LEVY NUCLEAR PLANT, UNITS 1 AND 2
DOCKET NOS. 52-029 AND 52-030
RESPONSE TO REQUEST FOR ADDITIONAL INFORMATION LETTER NO. 092 RELATED TO ACCIDENTAL RELEASES OF RADIOACTIVE LIQUID EFLUENTS IN GROUND AND SURFACE WATERS

Levy Nuclear Plant Units 1 and 2
Response to NRC Request for Additional Information Letter No. 092 Related to SRP Section 2.4.13 for the Combined License Application, dated May 7, 2010

NRC Letter No.: LNP-RAI-LTR-092

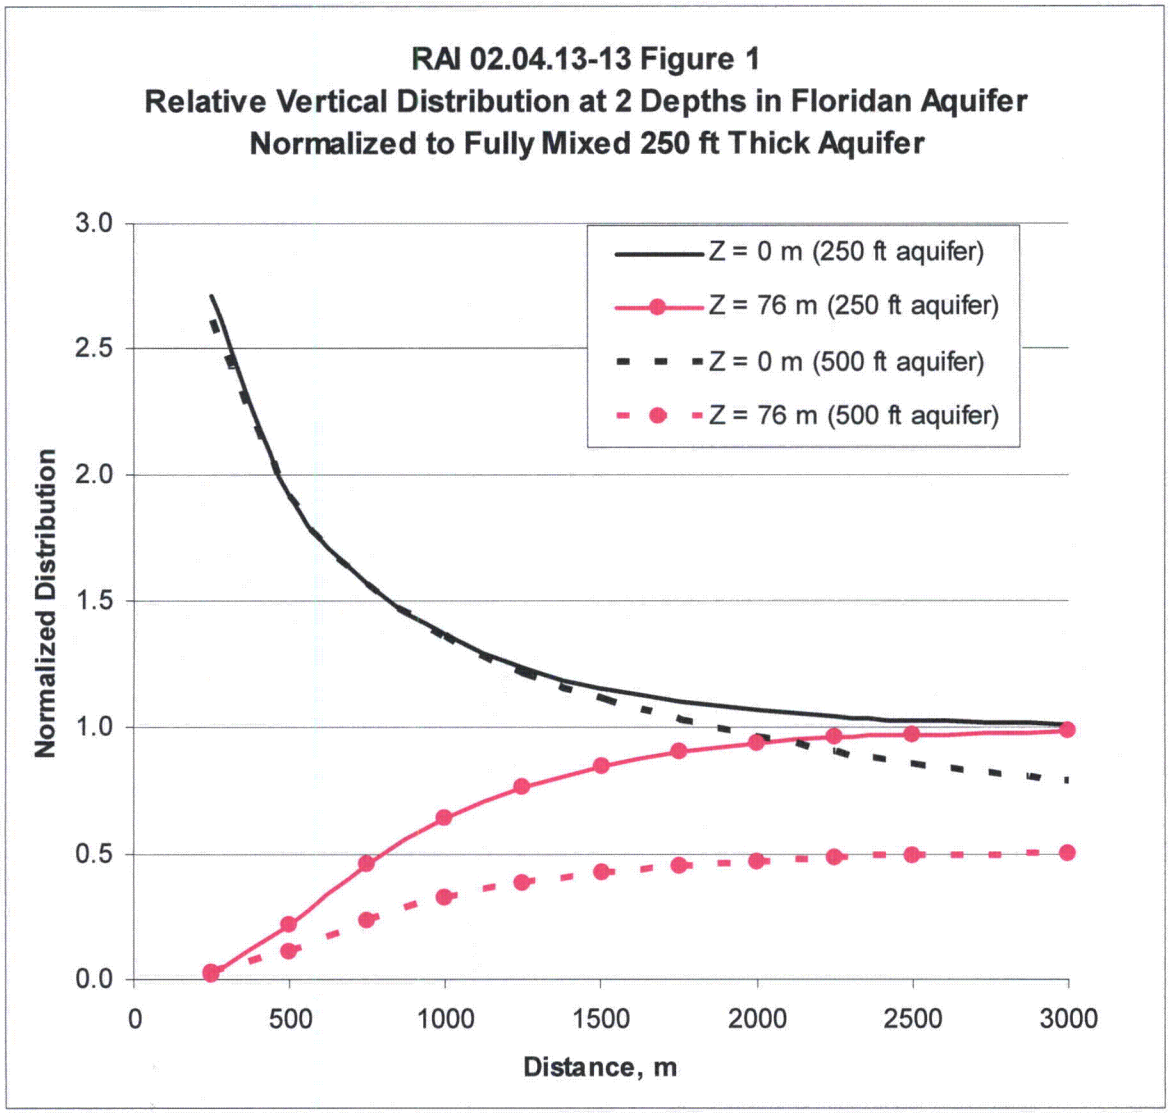
Provide a discussion of the degree of conservatism in the transport analysis included in FSAR Section 2.4.13, including discussion of the following.

1. The hydraulic conductivity value applied in the transport analysis as addressed in RAI 02.04.12-22.
2. The effective porosity values applied in the transport analysis as addressed in RAI 02.04.12-23.
3. The assumption that the released contamination is evenly distributed over an aquifer thickness of 250 ft. Clarify the value of aquifer thickness used in the calculations by including it in FSAR Table 2.4.13-203.
4. The groundwater head gradient applied in the transport analysis, considering that a more conservative value for the groundwater gradient than that used in the transport analysis is indicated by the baseline 2007 potentiometric surface map for the Upper Floridan aquifer presented in the recalibrated version of the DWRM2 groundwater flow model (|TMEM-123|). This potentiometric map is based on a more extensive well network that includes LNP site wells.

Figure 1 shows the normalized vertical distribution for a conserving contaminant (neither decaying nor retarded radionuclide) as a function of distance from the release location. Values are shown at the upper surface (Z = 0 m) and lower boundary (Z = 76 m) of the aquifer. The curves are normalized to the fully mixed case which provides a perspective on the fraction of mixing achieved: full mixing occurs at unity. The vertical distributions at the upper and lower elevations are within 7% percent of fully mixed when the center of the plume is 2,000 m from the release. The plume is assumed to have a horizontal linear velocity of 0.08 m/day, the value used in the Upper Floridan well receptor analysis in FSAR subsection 2.4.13.

Normalized concentrations would be less than those shown at 2,000 m if the same 250 ft deep well were assumed to be in a 500 ft thick aquifer. Figure 1 shows the vertical distributions are initially the same as the 250 ft aquifer but decrease below these values with distance from the release site. Decreases are due to the spread of the contaminants into the region below 250 ft. At 3,000 m the concentrations at Z = 76 m elevation approaches full dilution which is one-half the concentration of the 250 ft thick aquifer. The same figure shows that the upper elevation at Z = 0 m is still not well mixed. Therefore, the use of a 250 ft thick aquifer is conservative with the well 2,000 m from the source. The concentrations are confirmed in the supporting calculations to ensure they are well mixed across the 250 ft depth.
